City Planning Commission
Sacramento, California

- SUBJECT:
1. Negative Declaration
 2. Extension of Variance to Waive 3 of the 37 Required On-Site Parking Spaces for a 7,350+ Square Foot Medical Office Use in the General Commercial (C-2) Zone (Section 14-E)
 3. Extension of Variance to Waive the 6 Foot High Masonry Wall Required Between Residential and Non-Residential Land Uses (Section 14-E)
 4. Lot Line Adjustment to Merge two Parcels (P83-109)

Location: 3256 J Street

P83-109

SCHEMATIC SITE PLAN
 SCALE 1/8" = 1'-0"

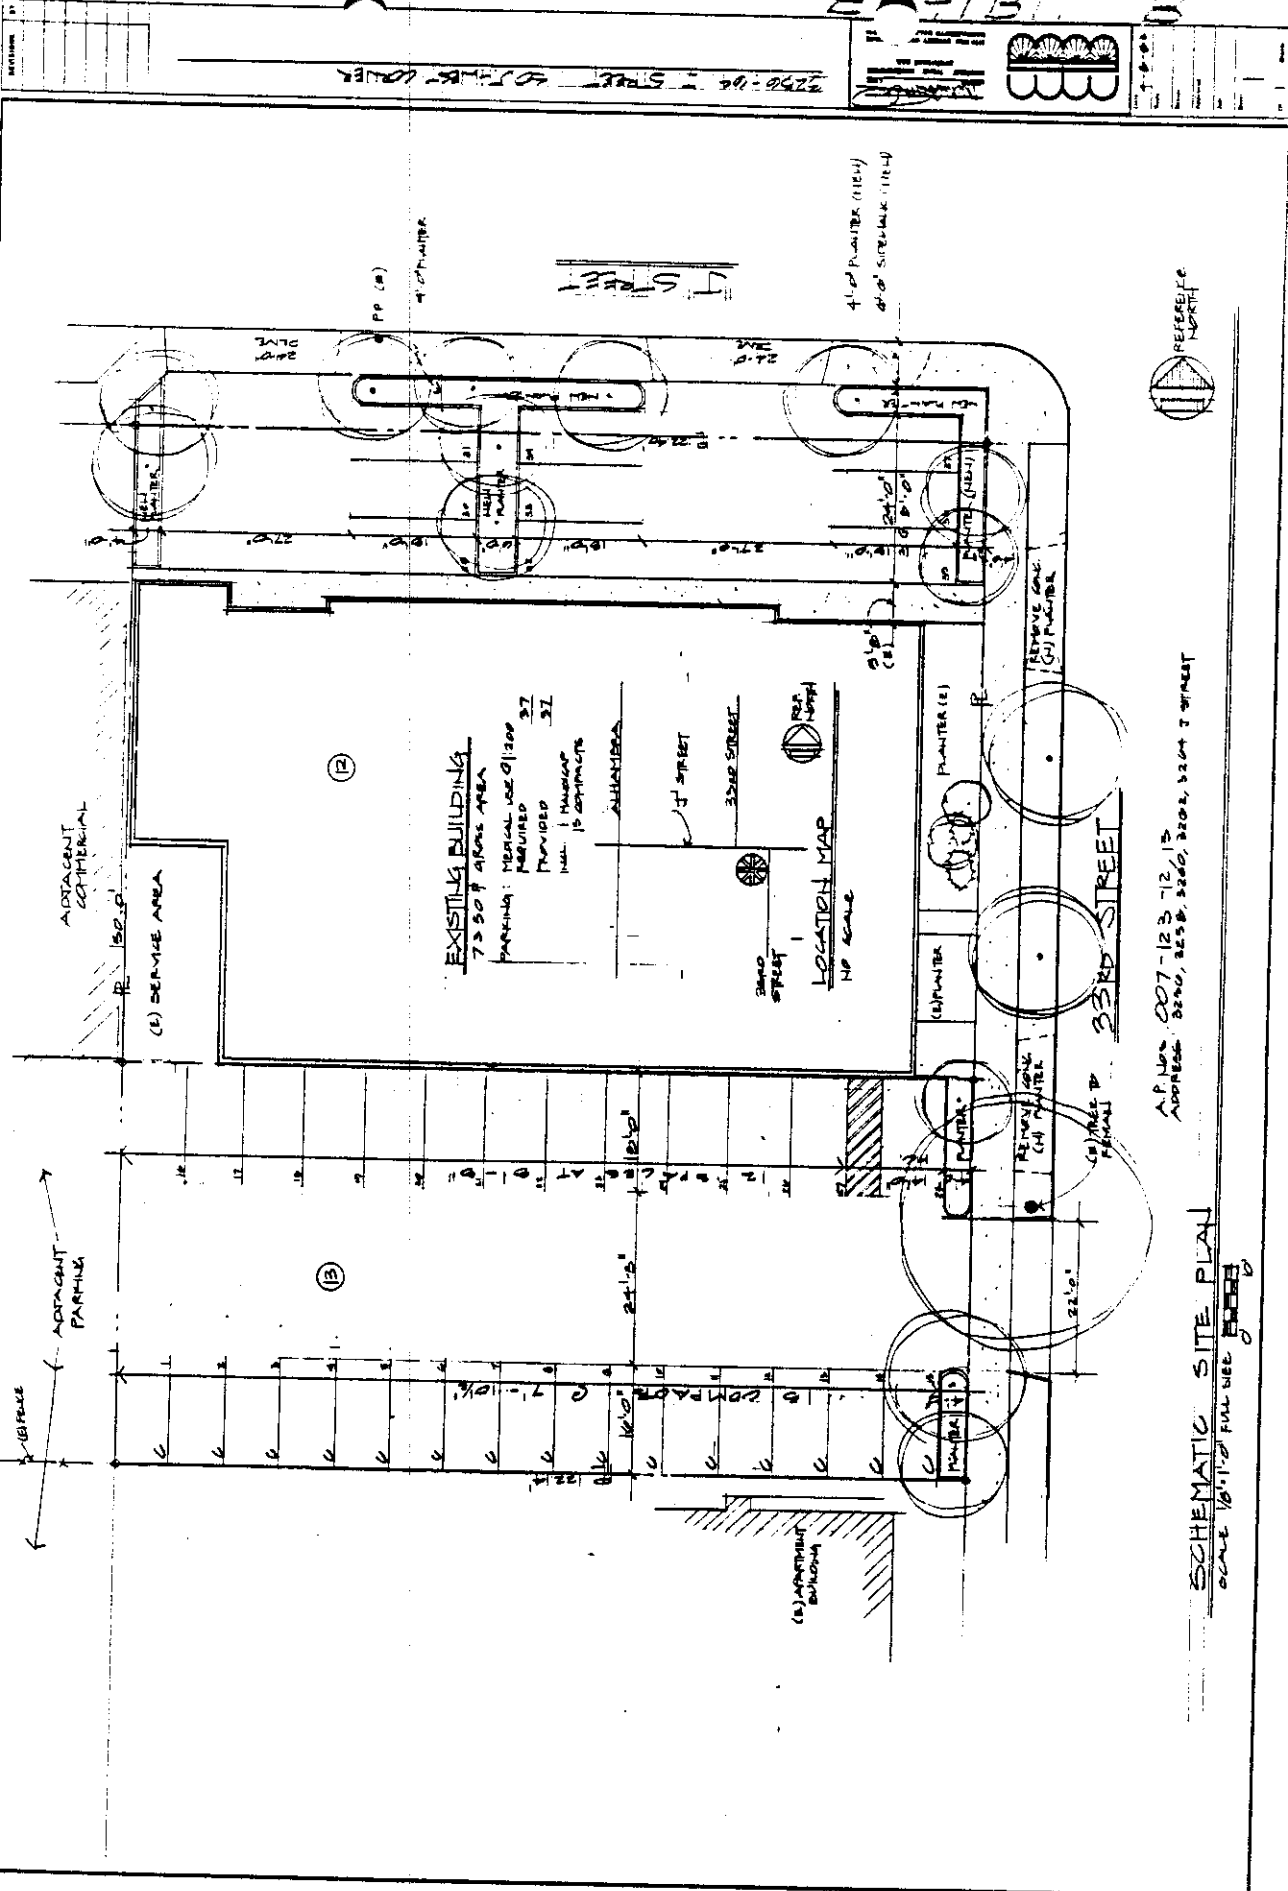
2. Currently there exists 13 on-site and 17 off-site parking spaces for the existing uses. The 13 on-site spaces consist of hazardous backout parking spaces onto 'J' Street. The City Traffic Engineer would prefer a prohibition of any parking spaces along the 'J' Street frontage (see attached letter). However, if approved per the applicant's proposal, the Traffic Engineer requests certain design modifications as described in the attached letter (see Exhibit C). One of these modifications includes the removal of a large Sycamore tree to allow for entrance into the parking lot. Staff recommends that this tree be saved if at all possible.

3. Among the entitlements requested is a variance to locate 28 of the required 37 spaces off-site and adjacent to the intended medical office building. Both of these parcels are in common ownership. Staff cannot find any justification for the granting of the variance and therefore recommends that this variance be denied and the two parcels be merged.

4. The applicant has requested a variance to waive the required masonry wall adjacent to the apartment building to the south. This wall is necessary to provide sound and noise attenuation as well as to insure screening of headlights. Staff cannot find any justification for the granting of this variance.

5. The applicant proposes to locate a landscaped planter in the public right-of-way adjacent to 'J' Street. Staff notes that a revocable permit is necessary for this improvement. To insure vehicle visibility as well as overall esthetics, staff recommends that a detailed landscape and irrigation plan be submitted to staff for review and approval prior to the issuance of building permits.

The Traffic Engineer does not support the parking arrangement along J Street. These two small parking areas will result in a continuation of cars backing out onto J Street. We must take the position that a less intensive use would require no use of public right of way.

1. The driveway on 33rd Street must be 24' wide as required in Code 38.164. The tree would have to be removed in order to provide proper driveway tapers even with the narrower width proposed by the developer.
2. Owners would be required to obtain a "Revocable Permit" from the City Council to use public right of way for private purposes.
3. The planter at the intersection would require slight modification to provide proper sidewalk clearance around existing street furniture.
4. The west driveway and parking bay has to be reversed to provide a reasonable transition in the sidewalk between the "new driveway and sidewalk" location and the "existing driveway to the west with the set back sidewalk". This will require relocation of the power pole.

- a. The applicant shall obtain and record a lot line merger prior to the issuance of building permits;
 - b. The applicant shall obtain a revocable permit for the improvements along 'J' Street, if necessary, prior to the issuance of building permits;

- c. The applicant shall submit a detailed landscape and irrigation plan for the proposed planting areas for staff review and approval prior to the issuance of building permits. The plans shall include the planting of deciduous trees and low drought-resistant ground cover;

- d. The applicant shall submit proof of a recorded easement prior to the issuance of building permits which allow access to 33rd Street from the adjacent parking lot. This easement shall also include the necessary language to allow through access to a possible through connection to the south or west.

- e. The applicant shall redesign the parking lot entrances per the City Traffic Engineer's requirements. However, the applicant shall request a modification of the driveway standards to retain the large Sycamore tree north of the proposed entrance. This tree shall not be removed. *unless approved for removal by the Planning Director after all other attempts have failed. (CPC amended)*

- f. *Applicant shall construct a fence of wood and brick columns (added by CPC).*
- Findings of Fact - Variance for reduced maneuvering area
